Addendum No. 2 March 29, 2023

WSU Sunrise Orchard Irrigation Line and Pond Washington State University Wenatchee, WA

Project No. 1262-2020 Washington State University Facilities Services, Capital

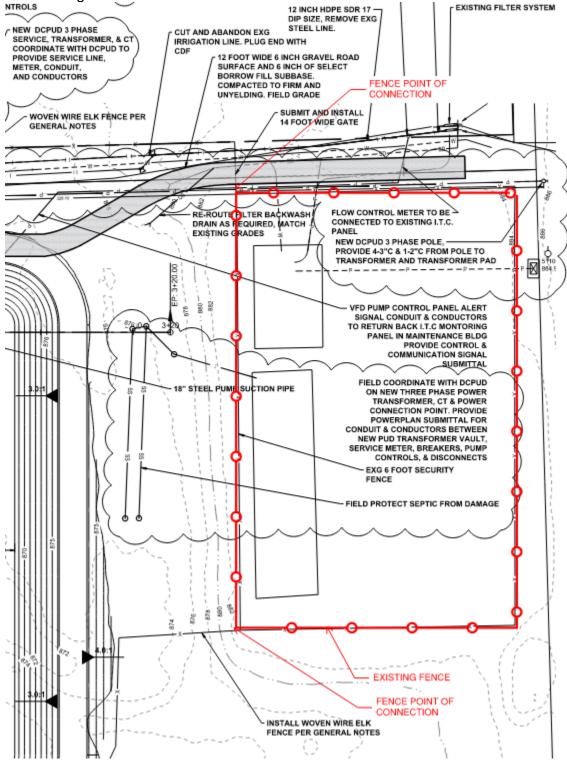
Q 14. Per Sheet C-320, Note "Install Woven Wire Elk Fence Per General Notes", and Note "Submit and Install 14' Wide Gate". Spec 32 31 00 is the fencing specification, but it neglects to provide specific dimensions for the layout of the "Elk Fence" per our subcontractor. Can a detail be provided for the desired fence and gate dimensions?

WSU Response: Refer to sheet C-002 of the project plans for the woven elk fence notes. Gate is to be steel chain link per the specifications, but shall comply with the height dimensions called out on C-002 fence general notes. Gates shall be submitted on for final approval.

- DWG 1-1. Drawing C-320 Pond Site Plan
 - Item 1. Delete drawing and replace with attached drawing.
- DWG 1-2. Drawing C-350 Irrigation Pond Details 1
 - Item 1. Delete drawing and replace with attached drawing.

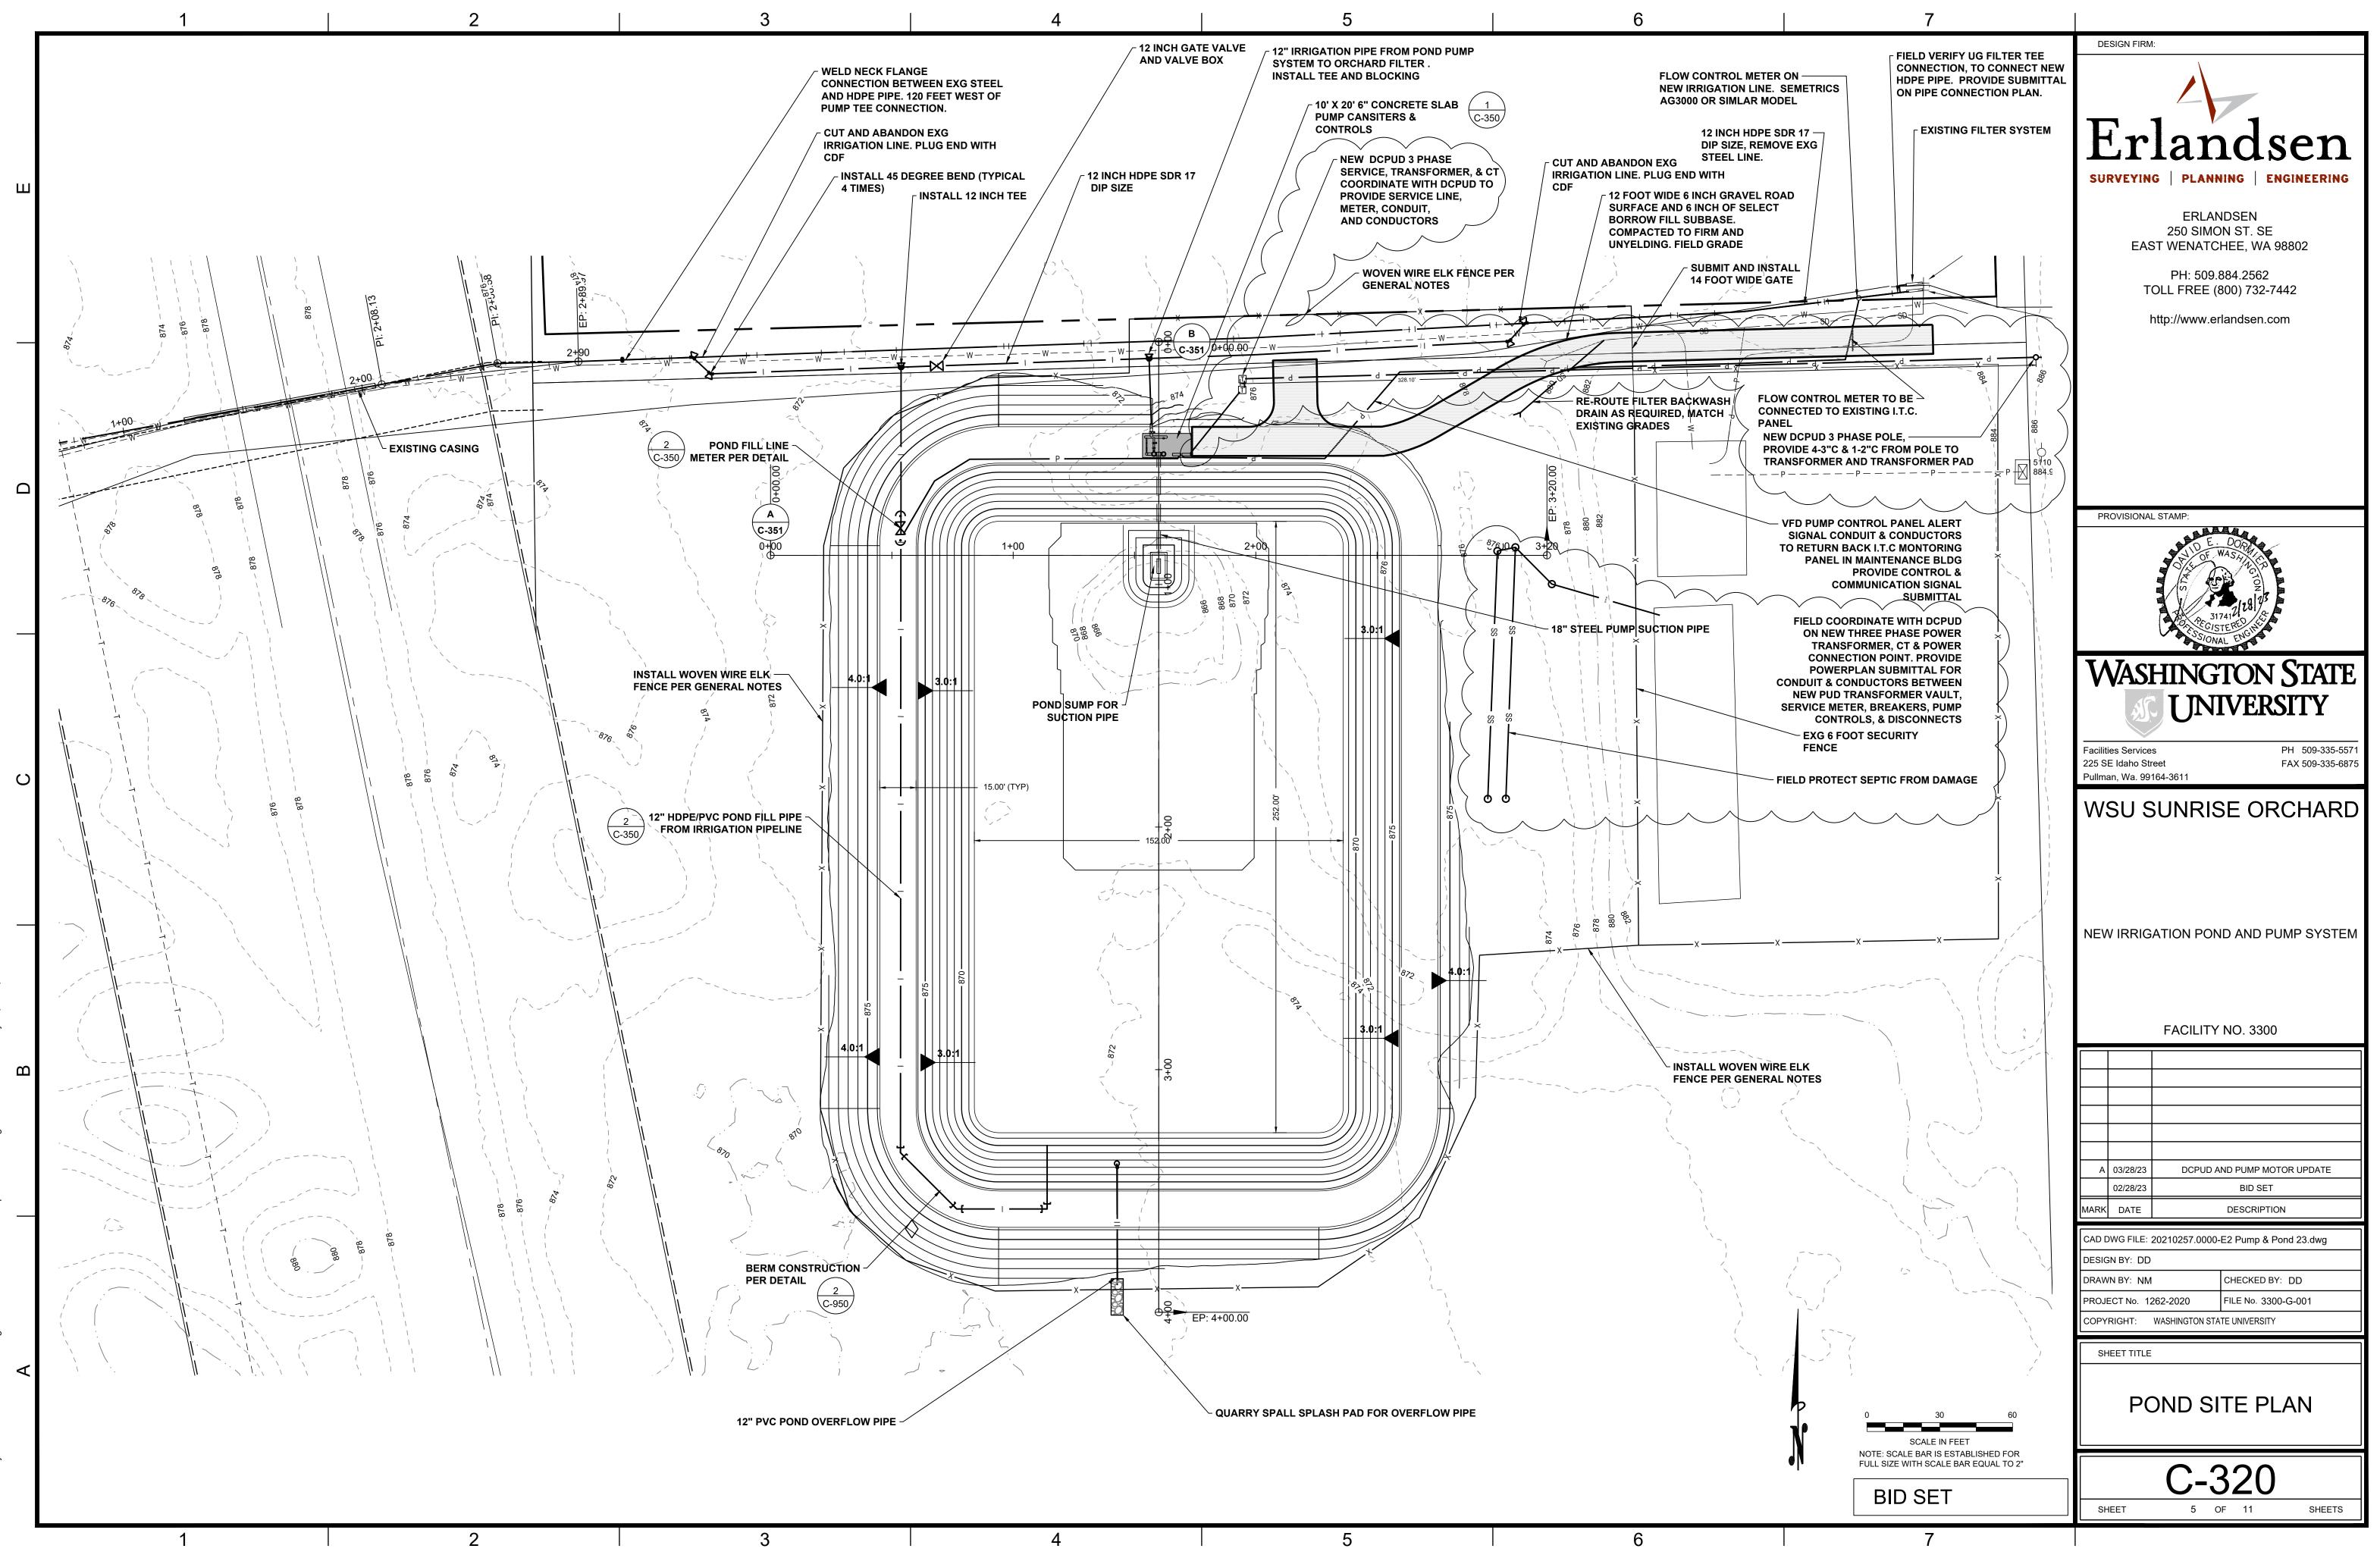
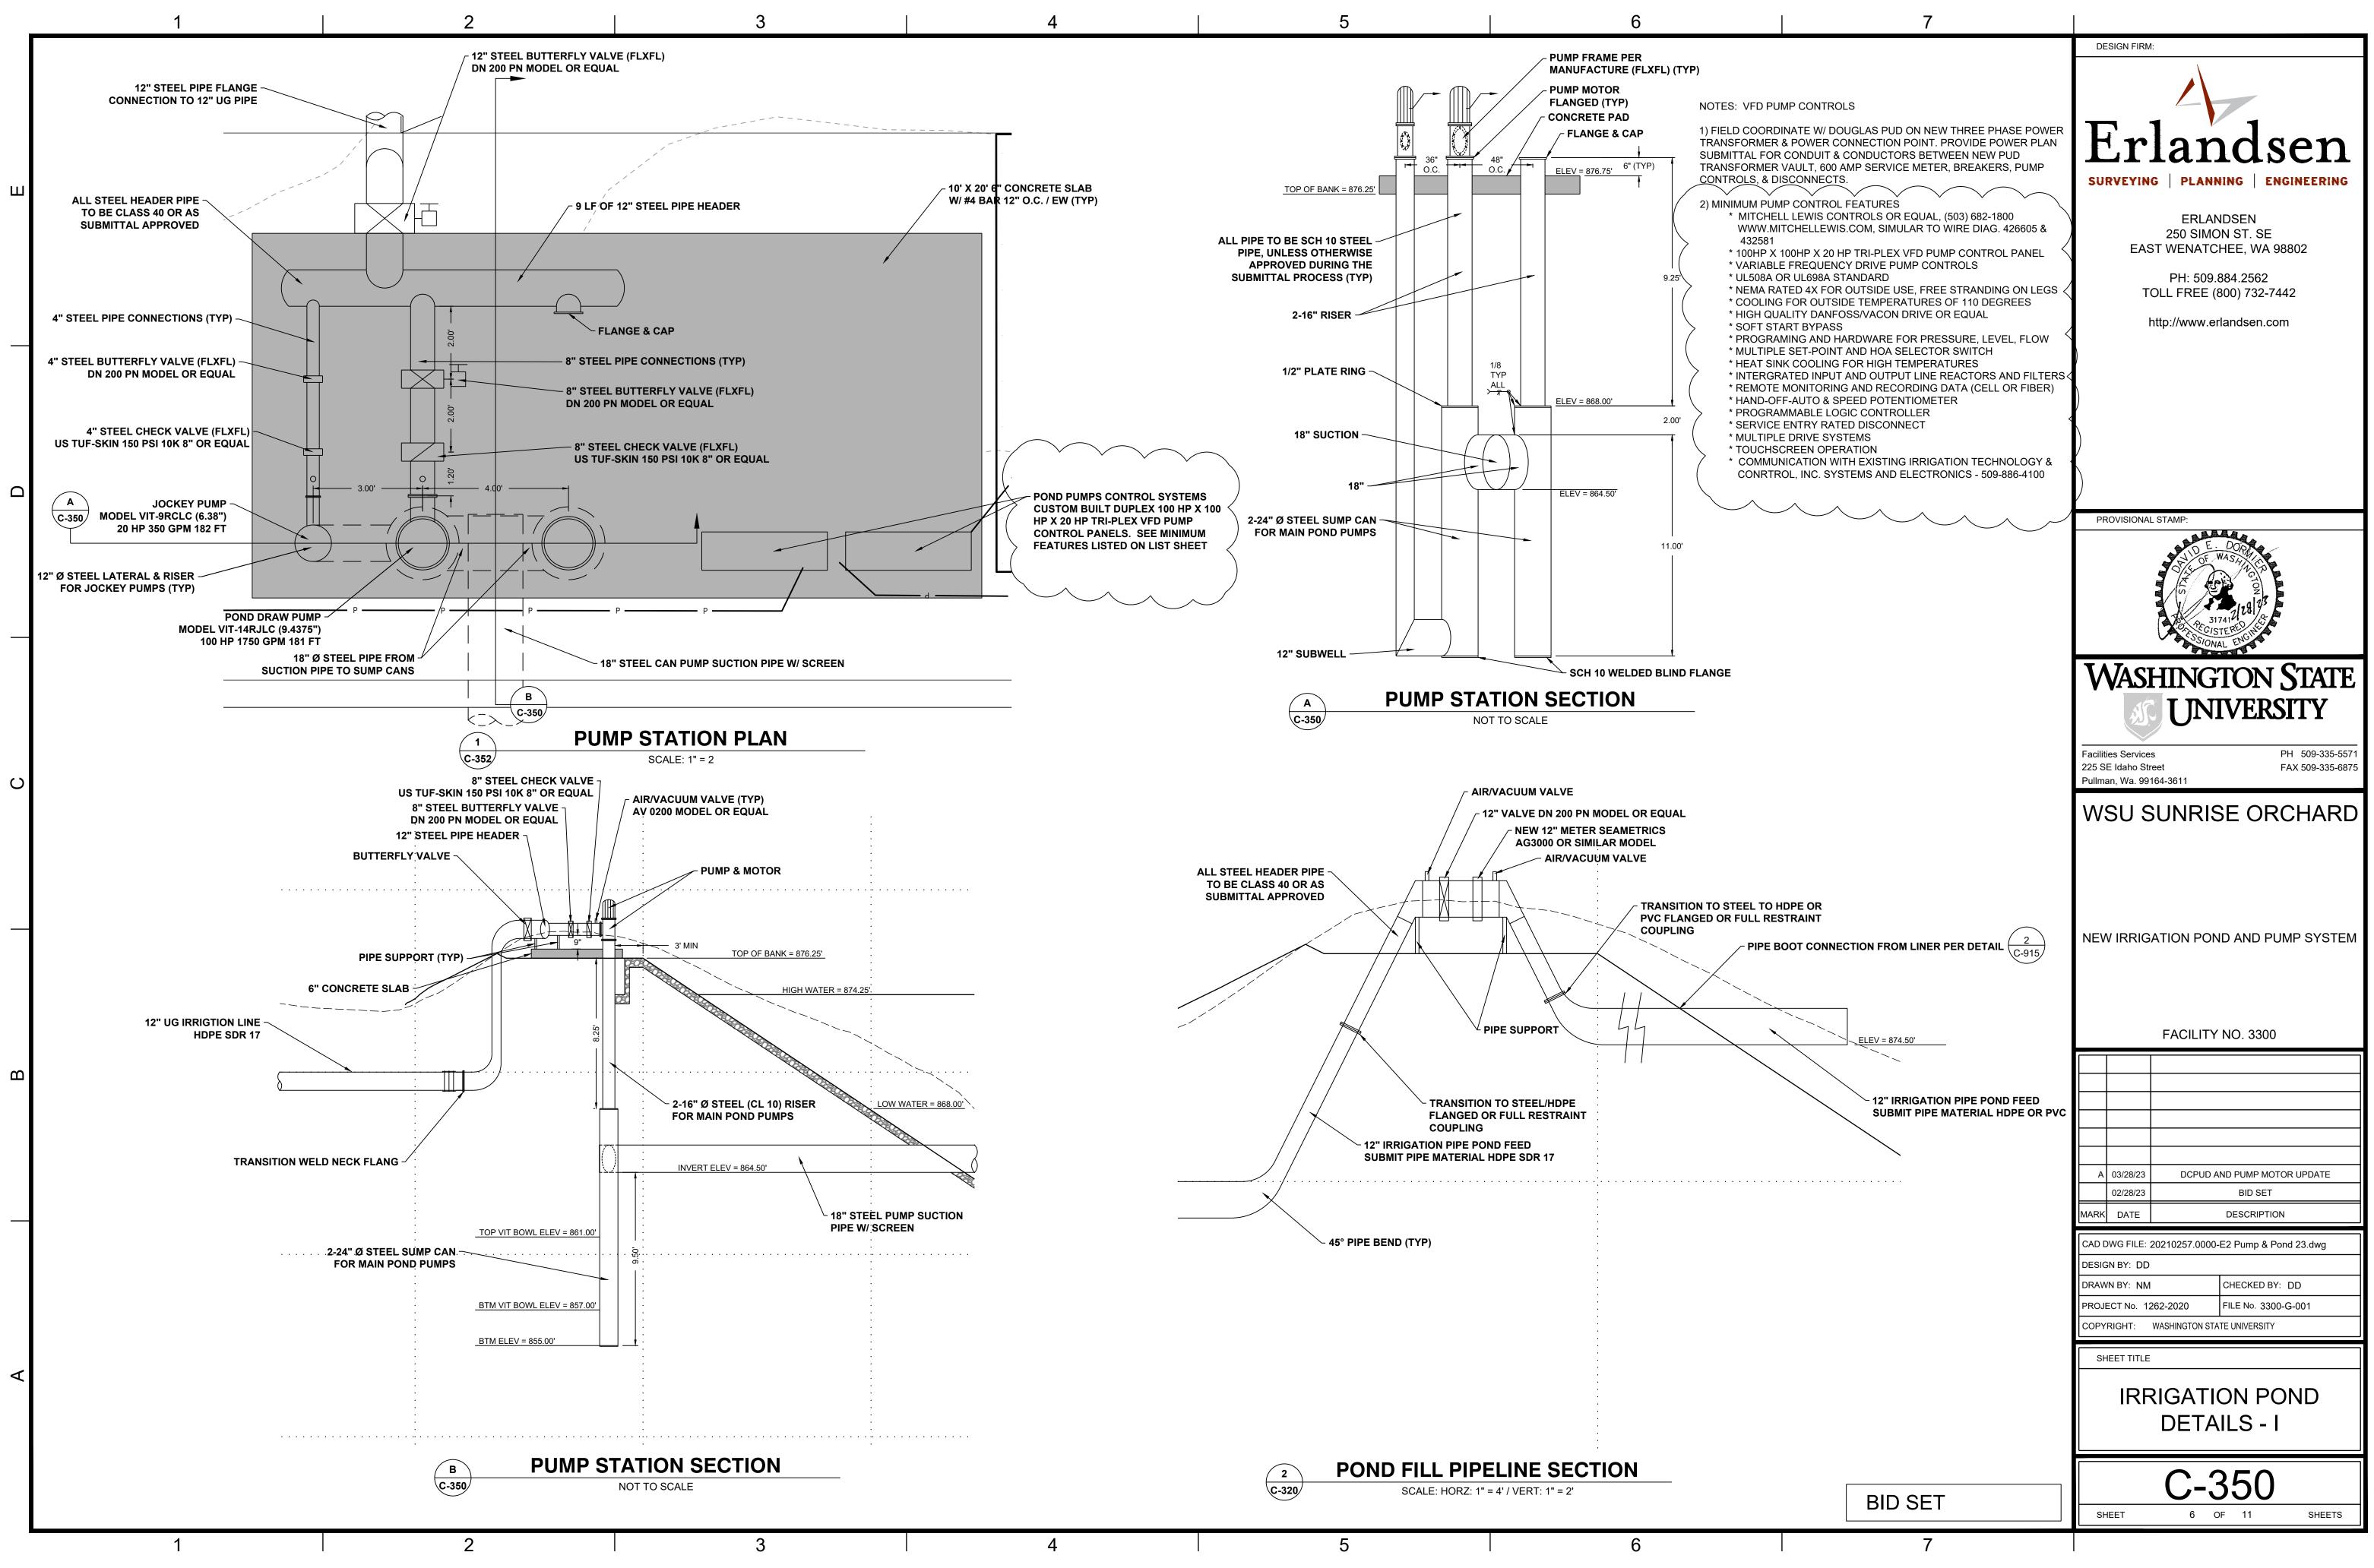
Q 9. The transformer size call out of "50 KVA" is incorrect for the Pump Horse power requirements of the project. DCPUD requirements for a 600 amp 3 phase CT'd transformer service will be significantly different than what is stated within plans and specifications.

Q 10. The padmount transformer will be required to be set within 100' of the pump station control service panel for efficiency requirements of the DCPUD. This is a significant increase & price change to plan drawings and specifications with regards to owners assumed contractor responsibility call-outs and or district provided services.

WSU Response: WSU will continue with the 600 amp service. Which will be a 500 KVA transformer whose final size and placement is by DCPUD. The 50 is a typo. CT and conduit have been added to the specifications based on the DCPUD service document in the addendum as noted above.

WSU Response: DCPUD has revised there first design provided to WSU to a new 3phase pole at sunrise court and 350 to 400 feet to the west the new transformer and CT will be set. Contractor shall provide the necessary infrastructure for panels, transformer pads, conduits, etc per the Drawings and the DCPUD 3-Phase Guidelines that have been added to this addendum for contractor reference. Q 11. The PUD requires that the contractor provide and install all required district owned electrical conduits on the incoming side of the transformer. If underground power is to be assumed as the plan sheets state. A significant increase in the amount of conduits will be required by the district to be installed prior to utility work being performed by the district. Quick trench footages look to be approx.. 450'+ of contractor electrical trenching that the district will require. The district would also require the supply and installation of 4 -3" conduits & 1-2" conduit in the trench. These rough numbers would set the transformer I would assume within 100' of the pump station.

WSU Response: The updated specification section and updated two drawings included with this address represent what we anticipate the final DCPUD design to be. Minor location changes may occur.
